Technical Service Bulletin (TSB)
Diesel Exhaust Fluid (DEF) Fluid Freezing

REFERENCE:	TSB: 14-005-24 GROUP: 18 - Vehicle Performance	Date:	June 28, 2024	REVISION:	14-003-23
VEHICLES AFFECTED:	2019 - 2022 (DJ) RAM 2500 Pickup 2019 - 2022 (D2) RAM 3500 Pickup 2019 - 2022 (DD) RAM 3500 Cab Chassis 2019 - 2022 (DP) RAM 4500/5500 Cab Chassis This bulletin applies to vehicles equipped with the 6.7L I6 Cummins Turbo Diesel engine (Sales Codes ETL and ETN) or a 6.7L I6 Cummins HO Turbo Diesel engine (Sales Code ETM).			MARKET APPLICABILITY: ☒ NA ☐ MEA ☐ SA ☐ IAP ☐ EE ☐ CH	
CUSTOMER SYMPTOM:	**Customers must experience a Malfunction Indicator Lamp (MIL) illumination and the vehicle must exhibit/set the following Diagnostic Trouble Code (DTC):** - P203E-00 - Reductant Level Sensor 1 Circuit Intermittent-Erratic. Customers may also experience one or more of the following: - Repeated freeze/thaw cycles of the urea tank to cause solid DEF crystals to form and settle on the focus tube, blocking the level sensor signal. - Rapid temperature swings from below freezing to above freezing causing an incomplete thaw of the DEF tank. When the vehicle is powered on, the diagnostic is enabled due to thaw

Fig. 1
DEF Tank Assembly

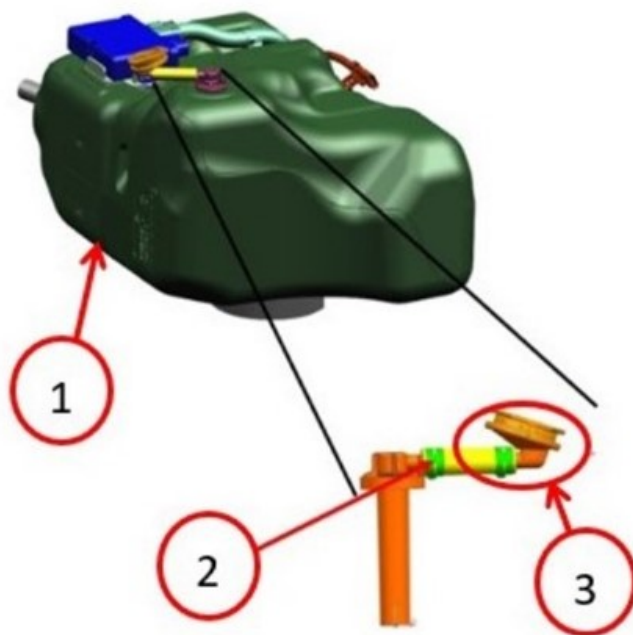
1. **Loosen the hose clamp on the Grade Vent Valve (GVV) hose and replace the GVV from the DEF tank
Fig. 1.
